Addendum No. 3

Reference: Regional Training Institute – TASS Phase 2
Utah National Guard – Camp Williams, Utah
DFCM Project No. 11020480

ADD-03

ISSUE DATE:	8 April 2013
RESPONSE TO:	Contractor Requests for Information
PROJECT:	**RTI TASS Complex, Phase II Administration & Billets Buildings** 17800 South Academy Street Utah National Guard Camp Williams **DFCM'S PROJECT #:** 11020480 **NGB'S PROJECT #:** 490444 **ARCHITECT'S PROJECT #:** 11024
OWNER:	**Utah National Guard** 12953 South Minuteman Drive Draper, Utah 84020-1726
SUBJECT:	**VARIOUS CLARIFICATIONS**
ATTACHED:	**Specifications:** 017419, 096723

A1 AE511 — **SECTION DETAIL (SILL @ LEVEL 1 W/ EXPOSED GRADE)**
1 1/2" = 1'-0"

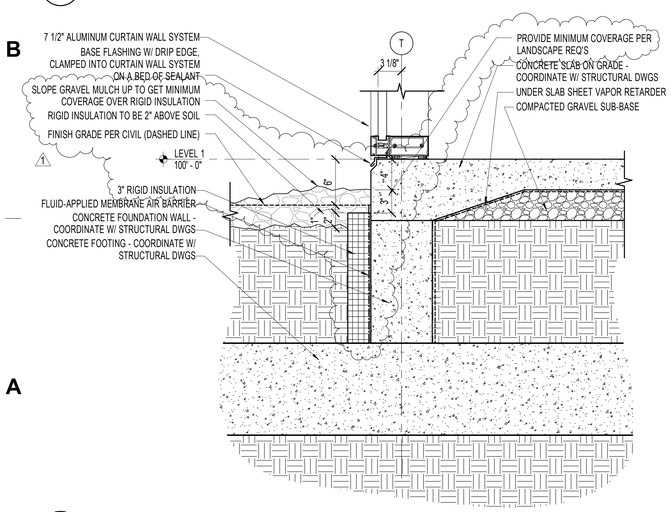
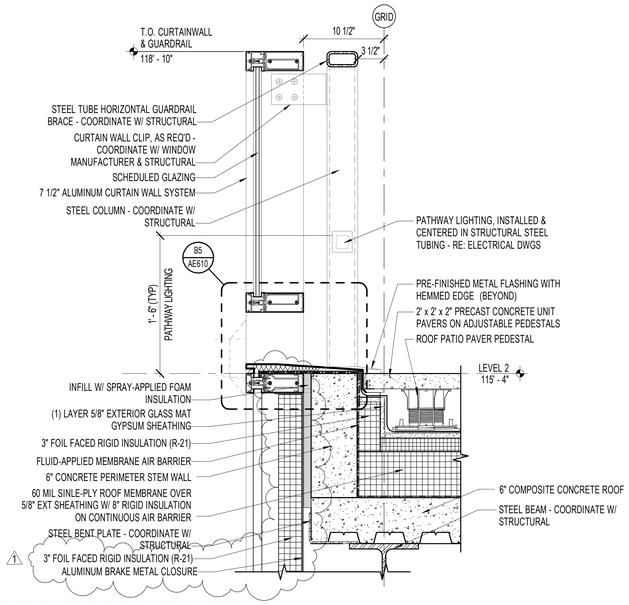
Item #	Sheet(s)	Amendment
A2.01	AE511	**REVISE** section detail A1/AE511 to show 3" rigid insulation on perimeter foundation walls, as shown on sheet provided. **REVISE** section detail D1/AE511 to show insulated aluminum closure panel, as shown on sheet provided. **REVISE** section detail D3/AE511 to show proper wall construction assembly, per wall type.
A2.02	AE512	**REVISE** section details D1 and D2/AE512 to have detail marker for solid surface sill, as shown on sheet provided.
A2.03	AE515	**REVISE** section detail C5/AE515 to show 3" rigid insulation on perimeter foundation walls, as shown on sheet provided. **REVISE** section detail D2/AE515 to have detail marker for solid surface sill and 3" rigid insulation on perimeter foundation walls, as shown on sheet provided.
A2.04	AE516	**REVISE** section detail A1/AE516 to show 1" thermal break, as shown in sheet provided. **REVISE** section detail D6/AE516 to show 3" rigid insulation on perimeter foundation walls, as shown on sheet provided.

C2 AE554 1 1/2" = 1'-0"

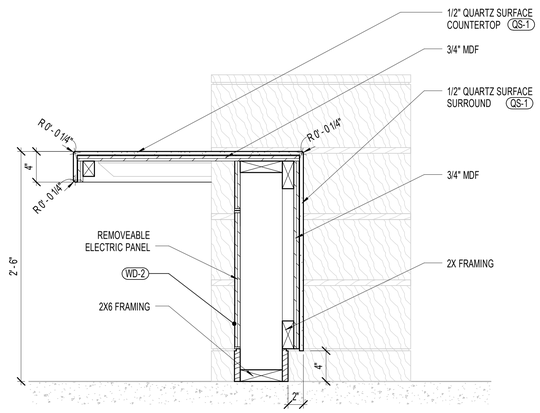
A2.05	AE554	**ADD** millwork details C2, C4, D4, D6, and E6/AE554, as shown on sheet provided. **REVISE** details A2, A3, A5, B2, B3, and B4/AE554, as shown on sheet provided. Hardwood inlay strips added to elevations, and electrical access panels indicated. **REVISE** detail C5/AE554 to have annotation as shown on sheet provided
A2.06	AE555	**REVISE** detail C5/AE555 to have a flush aluminum profile, as shown on sheet provided.
A2.07	AE601, AE602, AE603	**REVISE** glass type '8' to read as follows: *"8. 1-1/8" INSULATING-LAMINATED GLASS, SPANDRAL W/ INTERIOR INSULATED ALUMINUM CLOSURE PANEL"*
A2.08	AE610	**REVISE** sill detail D1/AE610 to show insulated aluminum closure panel, as shown on sheet provided.

FS1 / QF101 LEVEL 1 FOOD SERVICE EQUIPMENT PLAN - EAST
1/4" = 1'-0"

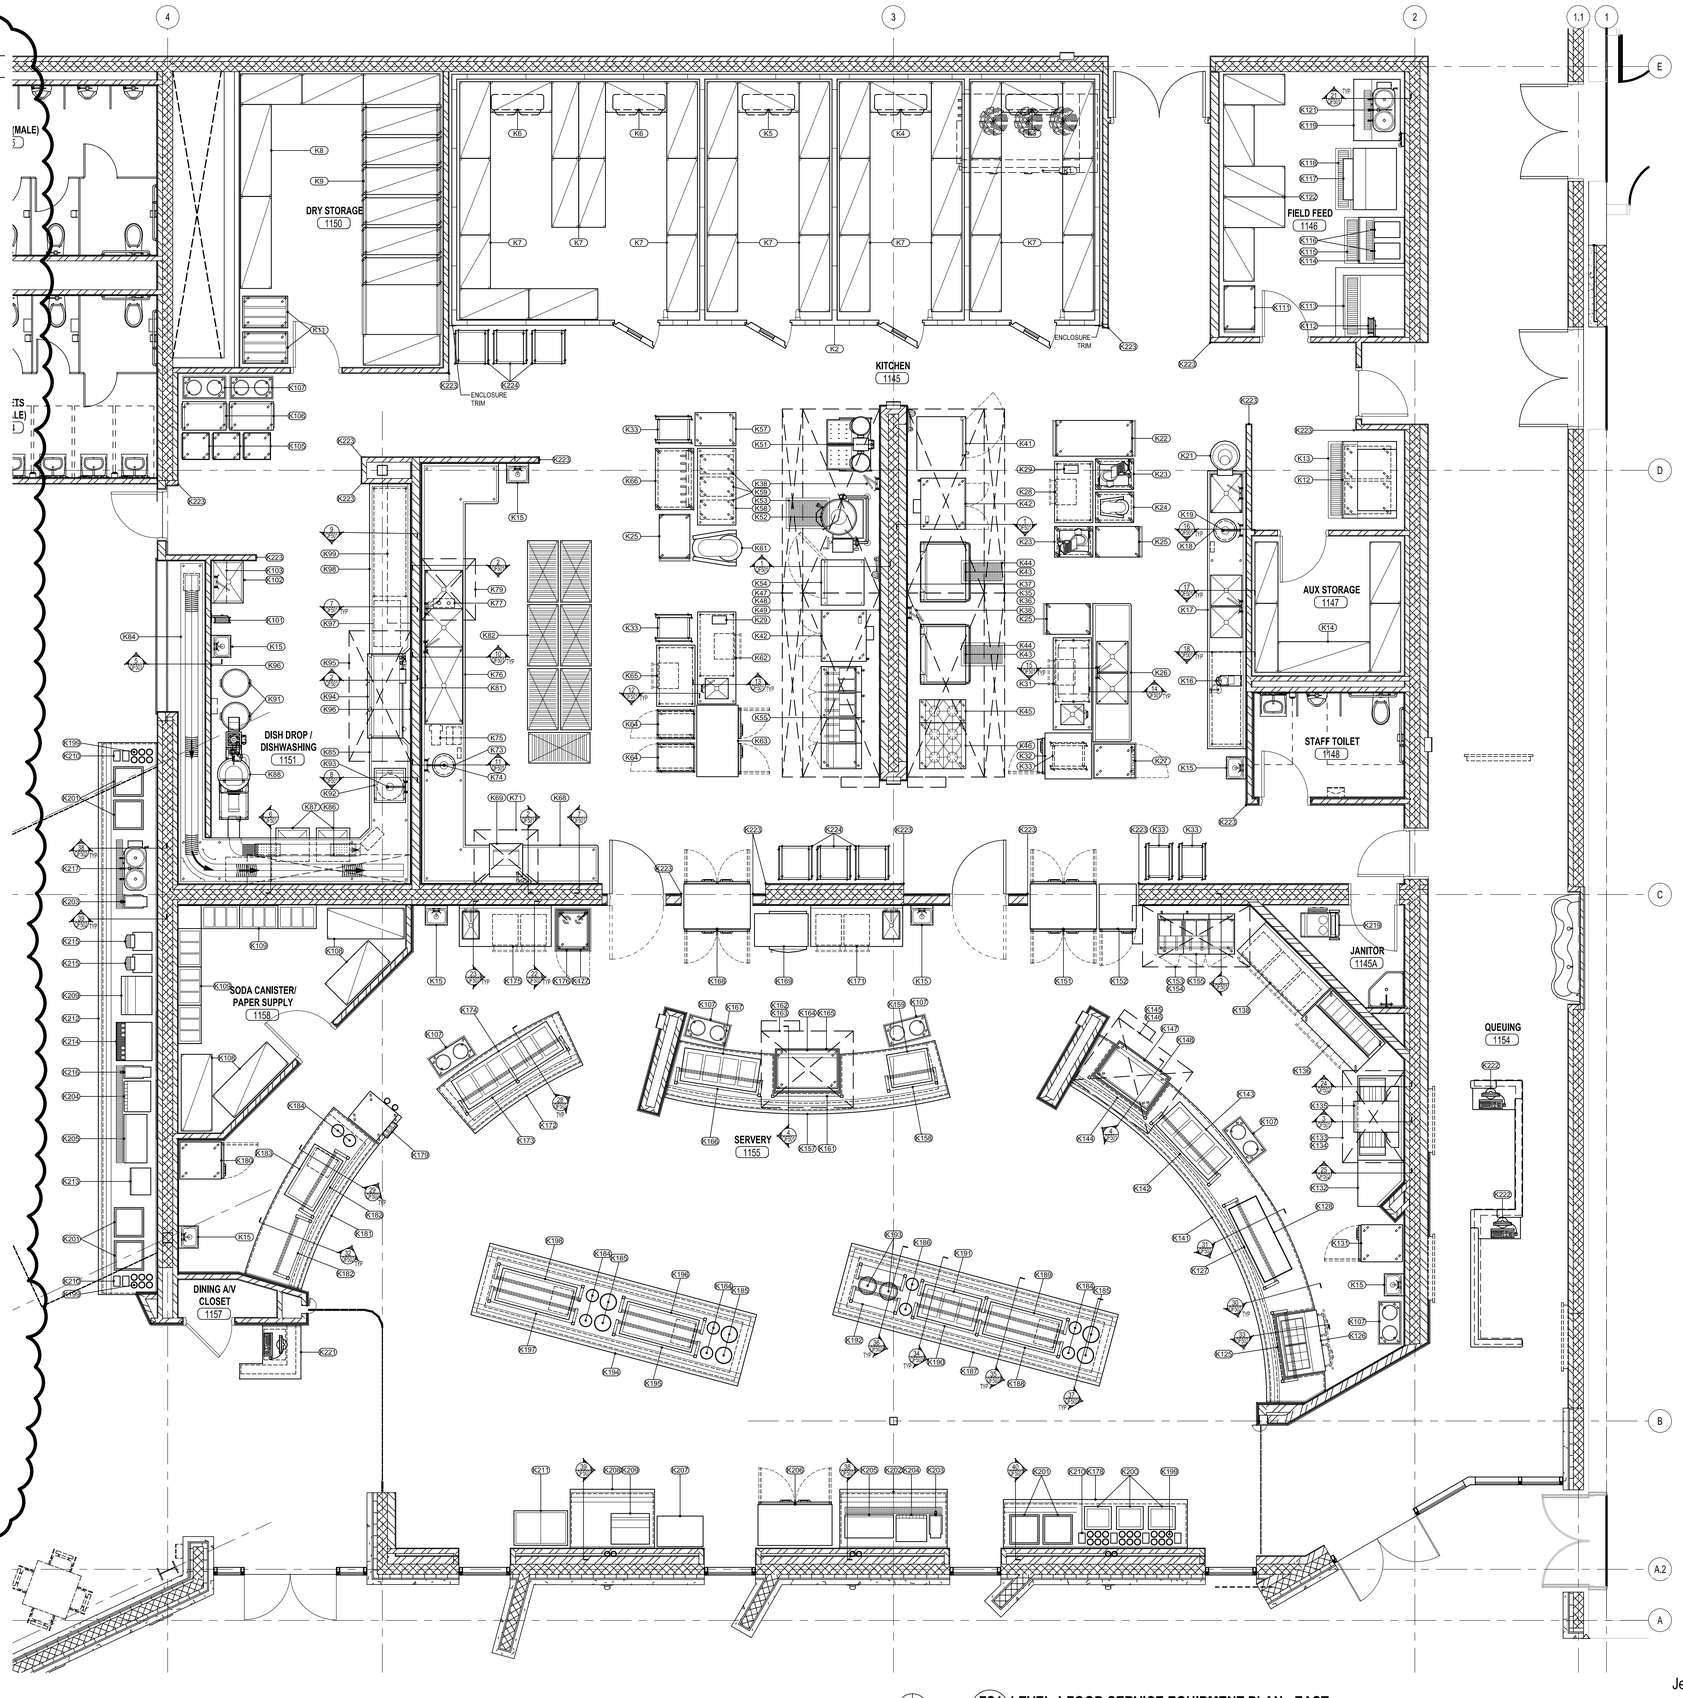
Item #	Sheet(s)	Amendment
A3.01	QF101, QF102	**REVISE** equipment schedule to show procurement and installation responsibilities for equipment, as shown on sheets provided.

A2 / AI601 SILL DETAIL (SOLID SURFACE EDGE)
6" = 1'-0"

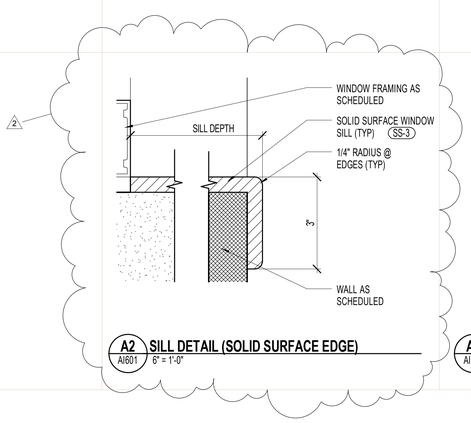
Item #	Sheet(s)	Amendment
B1.01	GI002, GI801	**ADD** sheet 'GI801 – BUILDING MOCKUP' to sheet index. **ADD** sheet GI801 to drawings as provided.
B1.02	AI601	**ADD** sill detail A2/AI601, as shown on sheet provided. **REVISE** finish legend to include floor finish 'RF1' and millwork finish 'WD2,' as shown on sheet provided. **REVISE** the following rooms to have floor 'RF1' and base 'RF1': 2160 and 2161.
B1.03	AI602	**REVISE** the following rooms to have floor 'RF1' and base 'RF1': 2260, 2261, 2360, and 2361.
